Access Compliance Report

Public Rights-of-Way

(Curb Ramps)

Intersection ID: 9655	Main Street: N_GRAHAM_ST	Cross Street: CONCORDIA_AV	Location: S
ADA ID: 8D452C4F2F2B	Ramp Type: PerpDiag	Initial Pass/Fail: Fail	Overall Compliance: No
Severity Score: 27.5			
Codes/Mitigation Info/Possible Solution		Field Measurements/Component Compliance

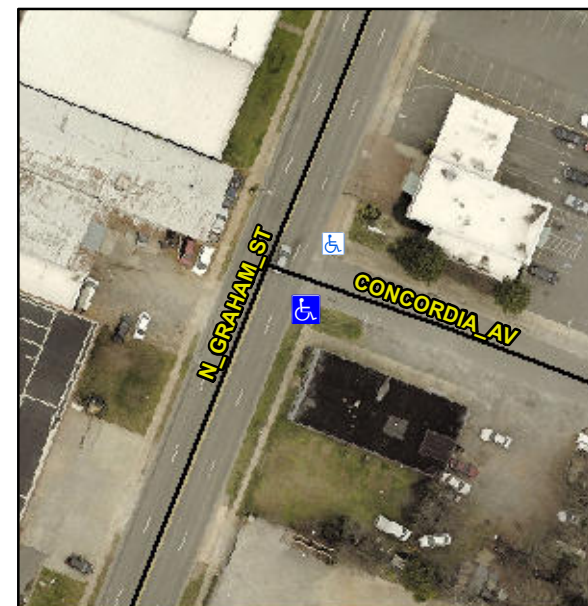
Not Found, R304.2.2, R302.7

Compliance	Description	Data	Compliance	Description	Data
N/A	Ramp Length (in)	90.0	No	Ramp Slope (%)	8.7
Yes	Ramp Width (in)	64.0	Yes	Ramp XSlope (%)	1.6
N/A	Flare Type LT	N/A	N/A	Flare Type RT	N/A
N/A	Flare Slope LT (%)	N/A	N/A	Flare Slope RT (%)	N/A
N/A	Flare Traversable LT?	N/A	N/A	Flare Traversable RT?	N/A
N/A	Landing Length (in)	N/A	N/A	DWS Provided?	N/A
N/A	Landing Width (in)	N/A	N/A	DWS Contrast?	N/A
N/A	Landing Slope (%)	N/A	N/A	DWS Length (in)	N/A
N/A	Landing X Slope (%)	N/A	N/A	DWS Full Width?	N/A
N/A	Landing Curb? (Y/N)	N/A	N/A	DWS Offset (in)	N/A
N/A	Shared Landing?	N/A			
N/A	Gutter Ponding?	N/A	N/A	Gutter Slope (%)	N/A
N/A	Gutter Lip Ht (in)	1.5	N/A	Gutter X Slope (%)	N/A
N/A	Painted X Walk1?	No	N/A	Painted X Walk2?	No
	X Walk 1 Direction	To NE		X Walk 2 Direction	To NW
N/A	X Walk 1 Width (in)	N/A	N/A	X Walk 2 Width (in)	N/A
	X Walk 1 Slope (%)	1.5		X Walk 2 Slope (%)	5.5
	X Walk 1 X Slope (%)	3.0		X Walk 2 X Slope (%)	1.3

N/A	Ramp inside XWalk1?	N/A	N/A	Ramp inside XWalk2?	N/A
	Road Slope (%)	1.8	N/A	Clear Space?	N/A
	Road X Slope (%)	4.6	N/A	Clear Space to XWalk (in)	N/A
N/A	Any Obstructions?	N/A	N/A	Storm Grate/Utility Hazard?	N/A
	Obstruction Type			Storm Grate/Utility Type	
		N/A			N/A
		No		Surface Condition? (G/P)	Poor

Remove & Replace Curb Ramp With Two New Directional Ramps or Equivalent.
